Design Review
Recommendation Meeting
MUP 3015728
October 2014

**Design Review
Recommendation Meeting
MUP 3015728**

Prepared for Alexandria Seattle by CollinsWoerman
October 2014

RESPONSE TO EARLY DESIGN GUIDANCE AND DRB RECOMMENDATION ON THE APPROVED MUP

BUILDING SECTION LOOKING NORTH

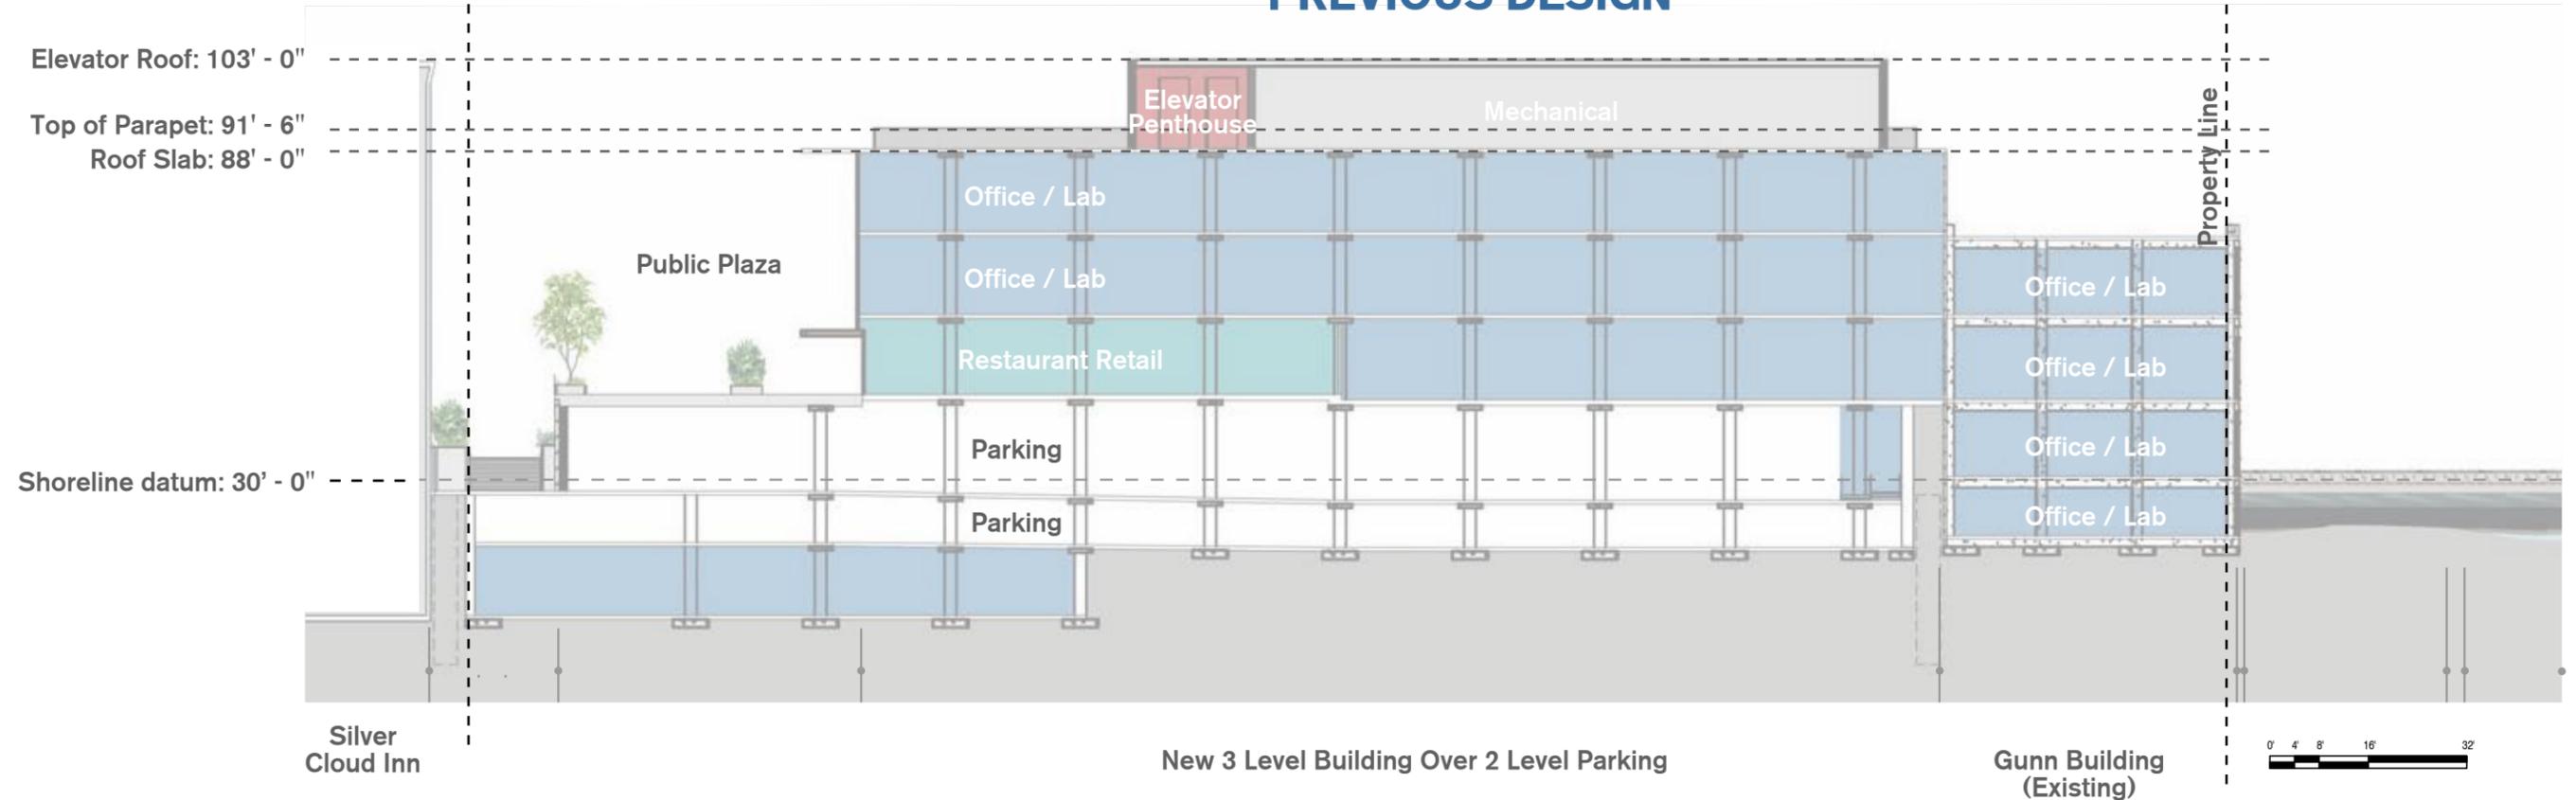
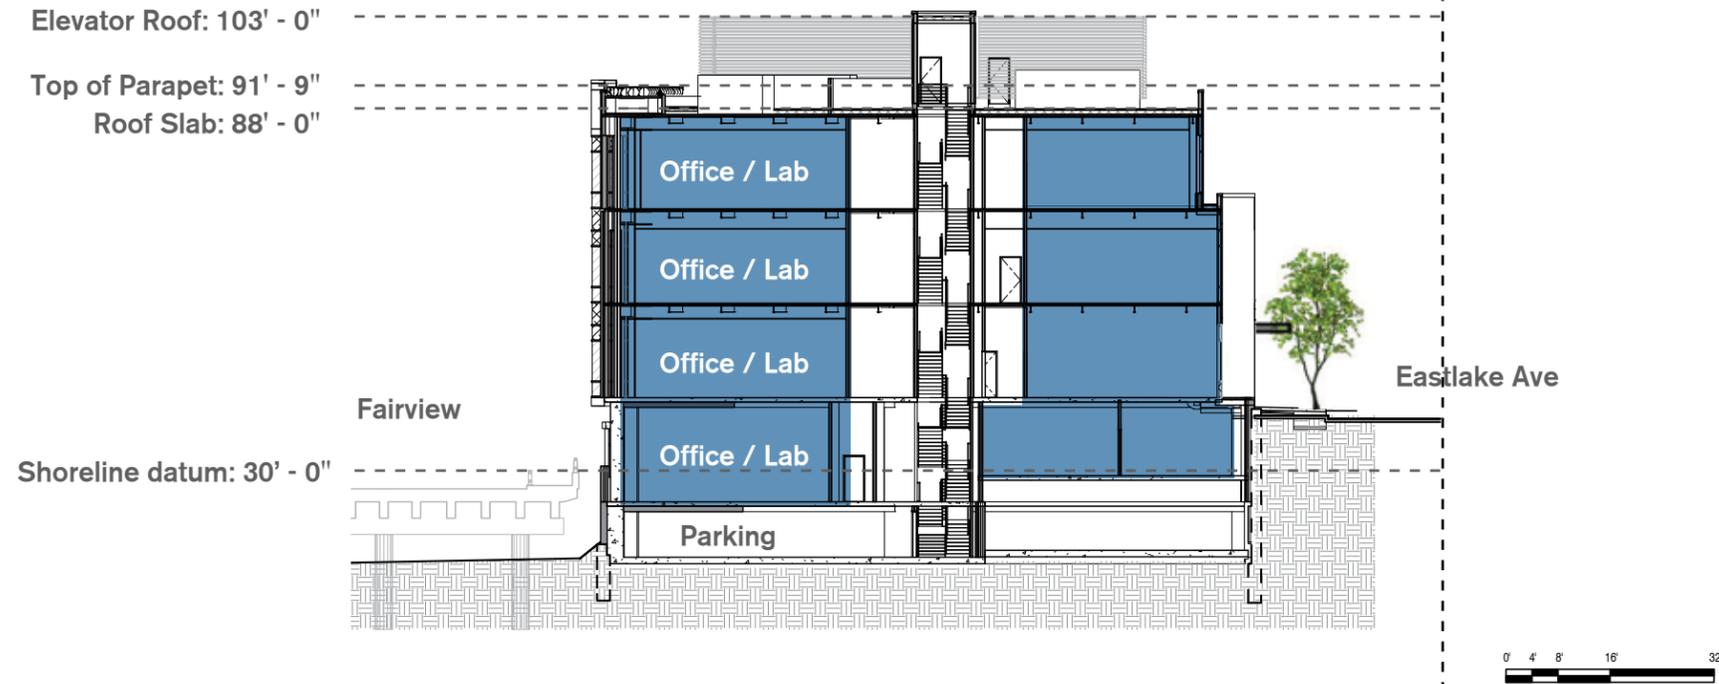
2. **Refine the roofscape/mechanical screening. Consolidate the HVAC units as possible and create a rooftop concept in concert with the building, building materials and surrounding area.**

The updated design has completely redesigned the rooftop features and mechanical areas. The internal core of the new design allows the rooftop penthouses to be located away from the building edges. The screening material has been changed to a metal panel vocabulary which more appropriately contrasts with the base building of brick, precast concrete and glass.

SOUTH ELEVATION

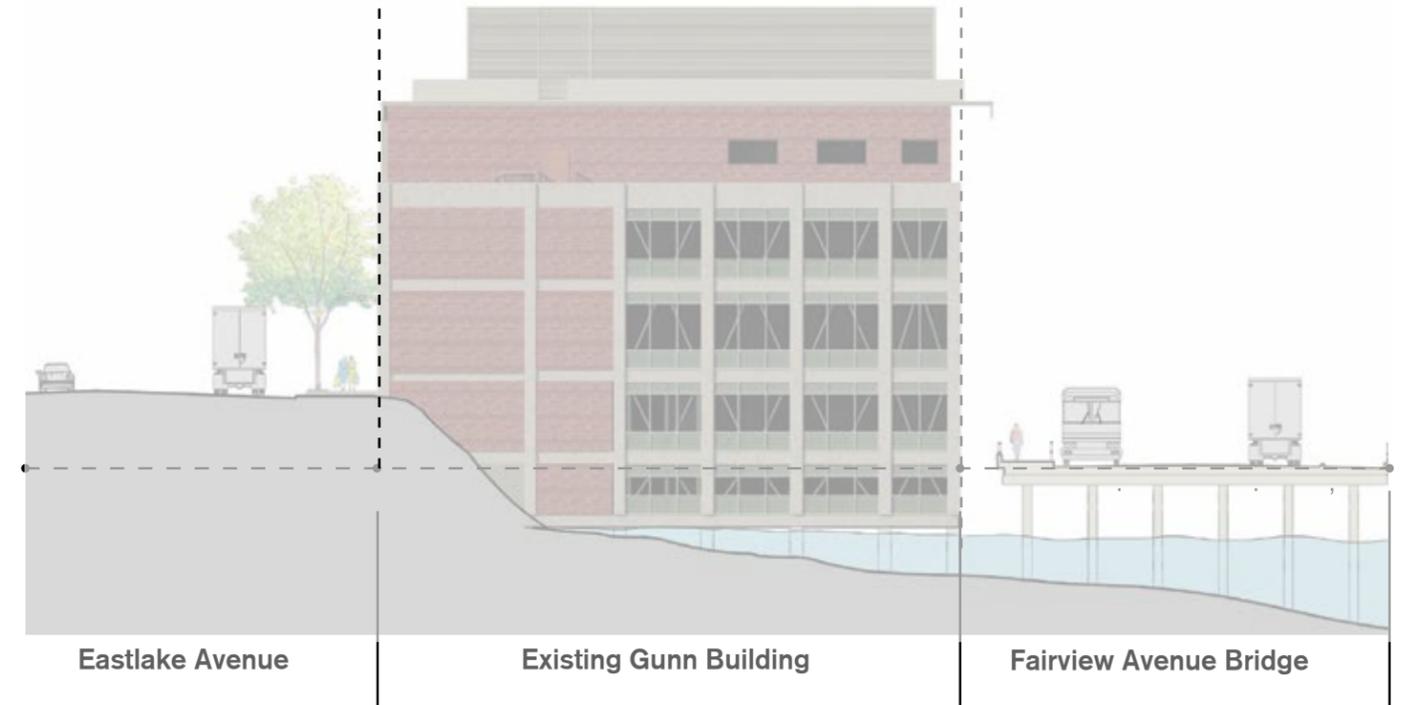
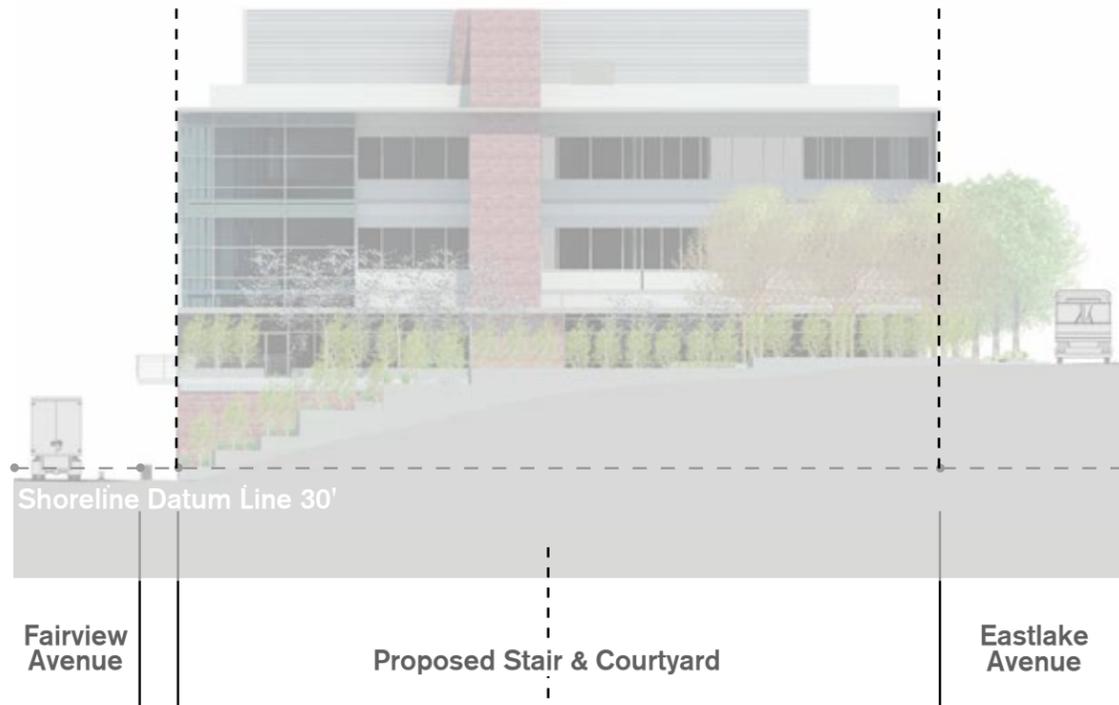
3. **The restroom core projection at the south façade (at the stairway next to the Silver Cloud, will need to be eliminated on levels 01 and 02, but can remain on levels 03, 04, 05 and 06.**

The updated design has relocated the restrooms and stairwell to the internal core such that they are no longer expressed on the exterior.

COMPARATIVE VIEW 1: Plaza View Looking East

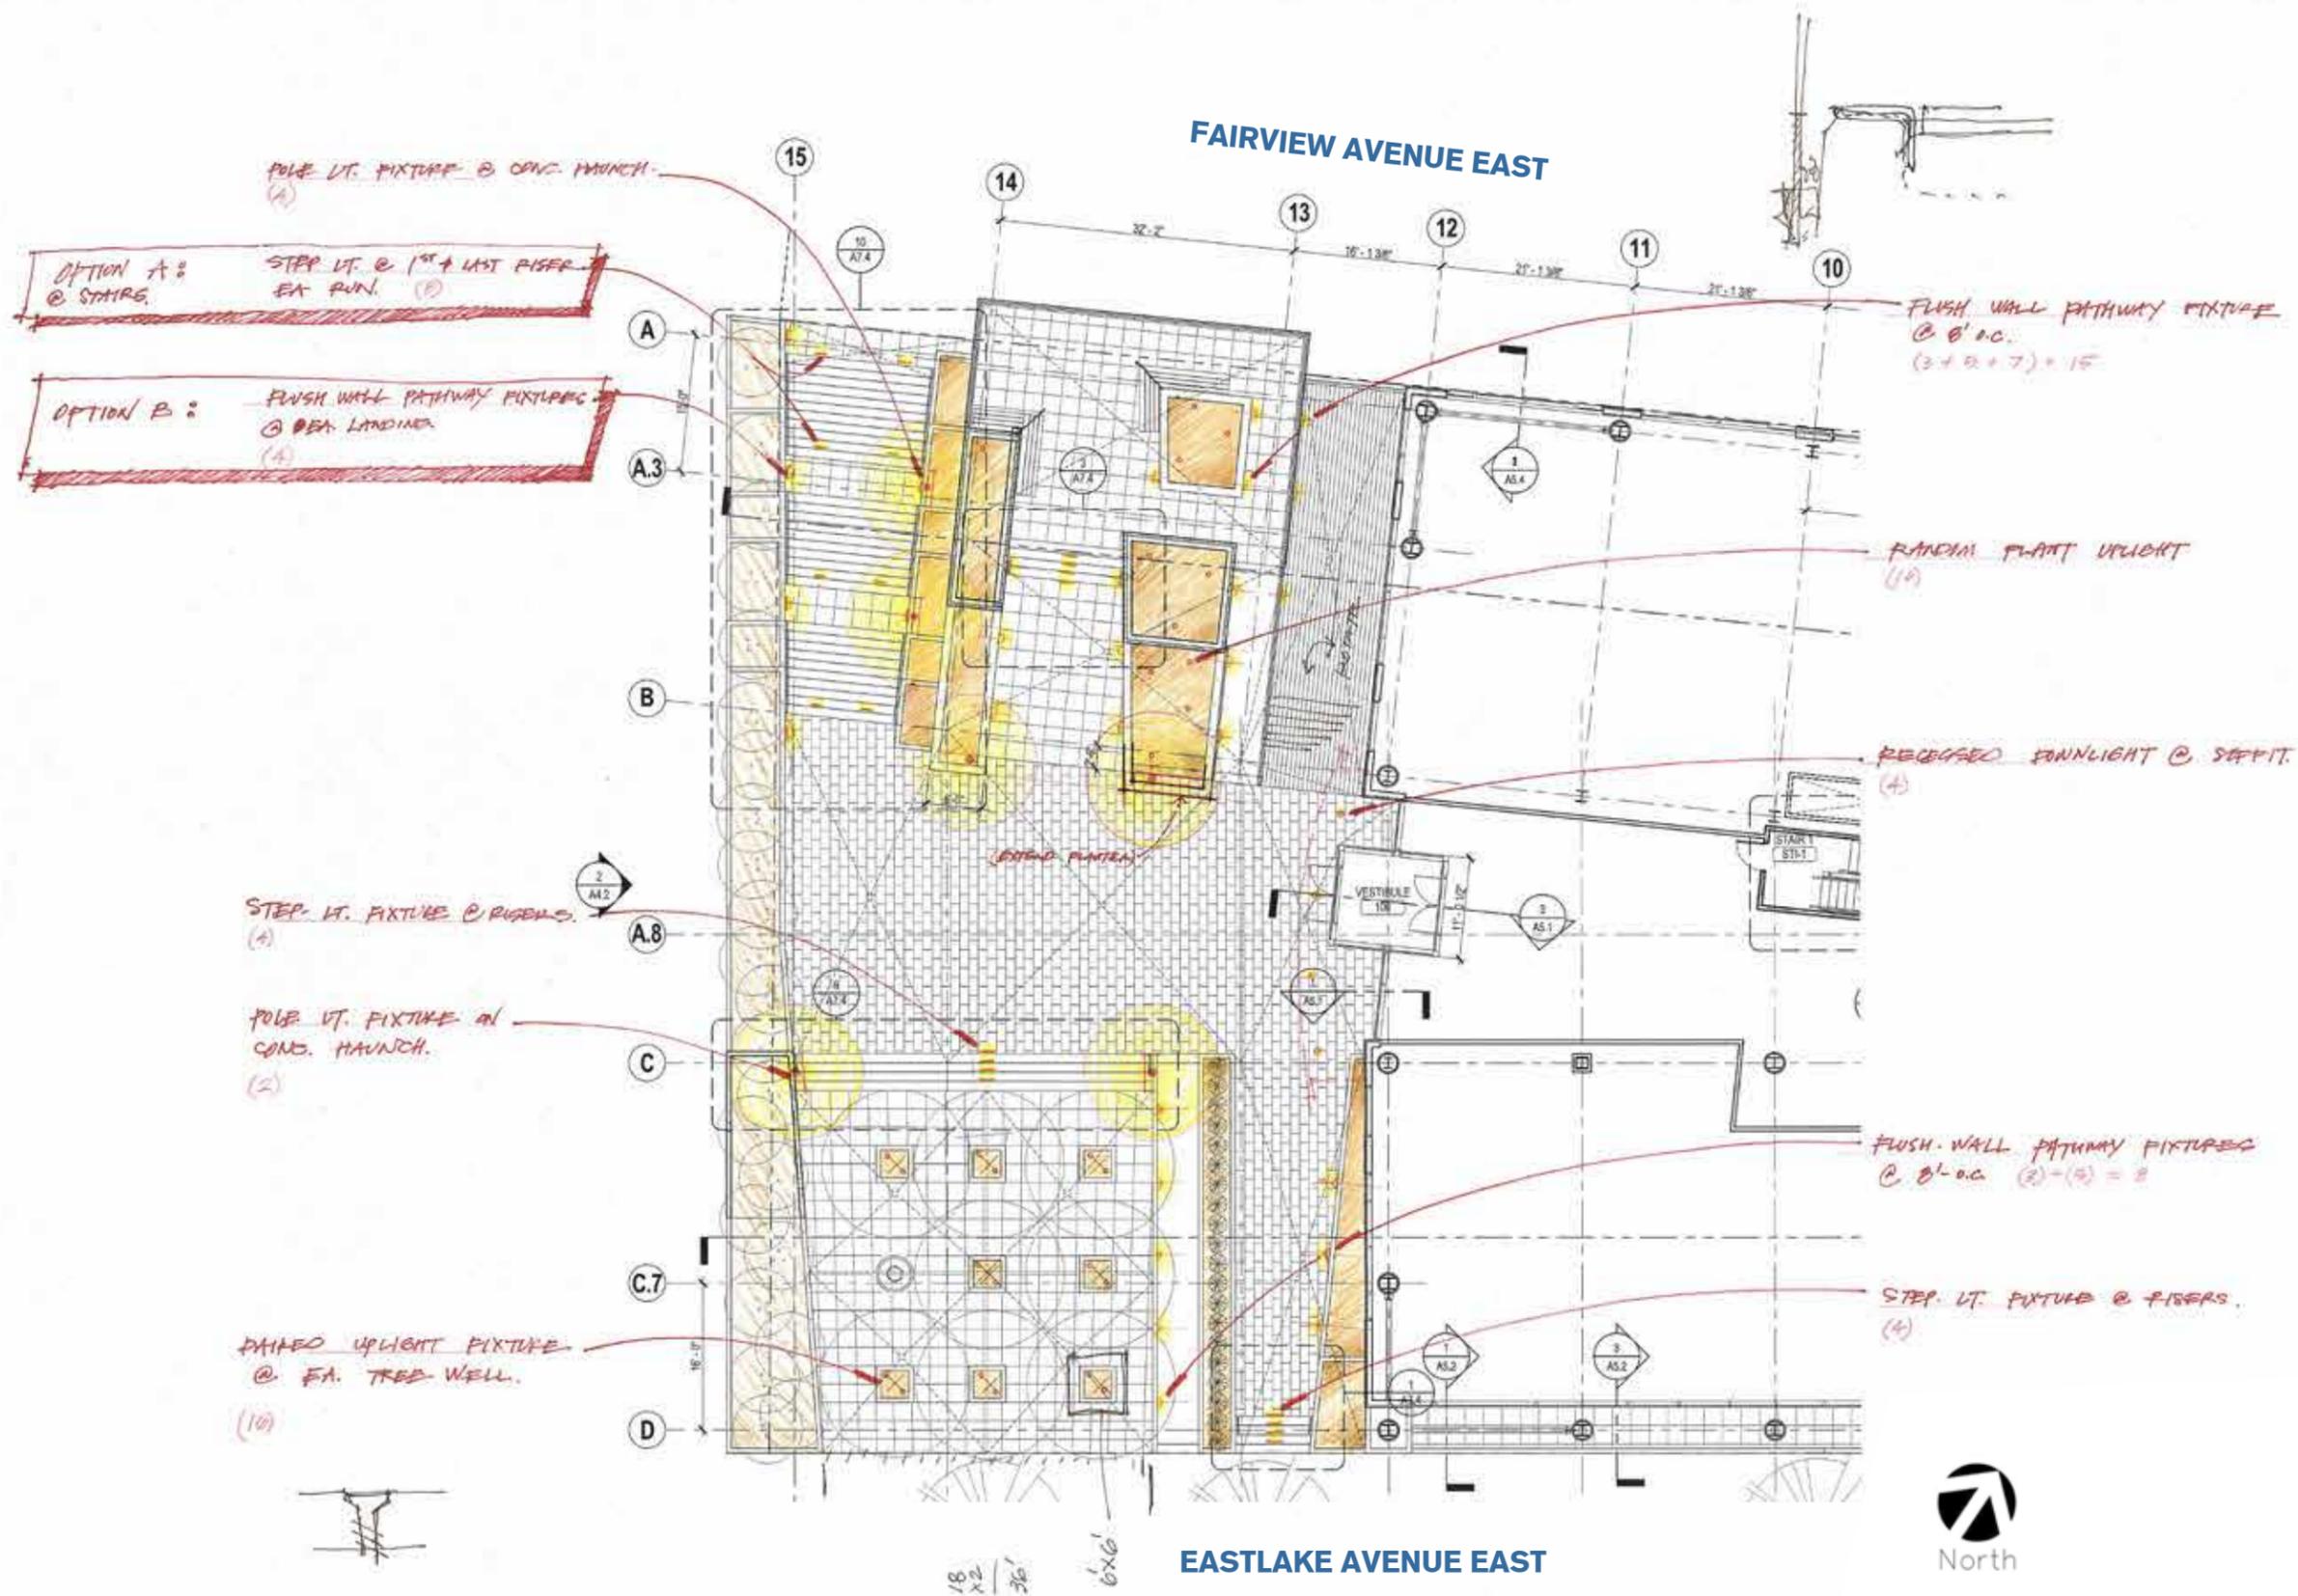
3. **Install large trees as per industry standards in the plaza.**

The updated design has done this and met the required Green Factor for the site.4. The building materials presented are appropriate. Refine the relationship of the material to its location on the building façade. Including rooftop materials, base materials, materials at the plaza façade and a continuous material expression across the whole of the plaza.
